To: Canadian Volvo Retailers
Subject: Service Action – S10082

**Service Action S10082: Air Condition Hose Conflict,
XC40 Model Year 2021 - 2022**

QB Instruction VCC-520555-1

Title	Connector Block to Air Conditioning Compressor (AC) Line	Page	1 (5)
Action	Product fix	Operation number:	97747-2

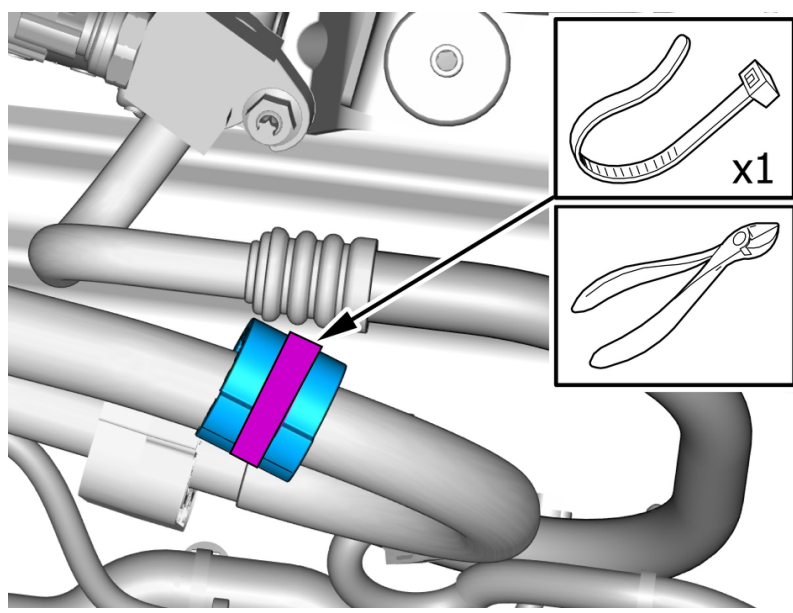
Adjustment

Install the marked component.

Caution! Make sure that the component is positioned correctly.

Install the marked component.

Use: Strip clamp , 983750

Use: Cutting pliers
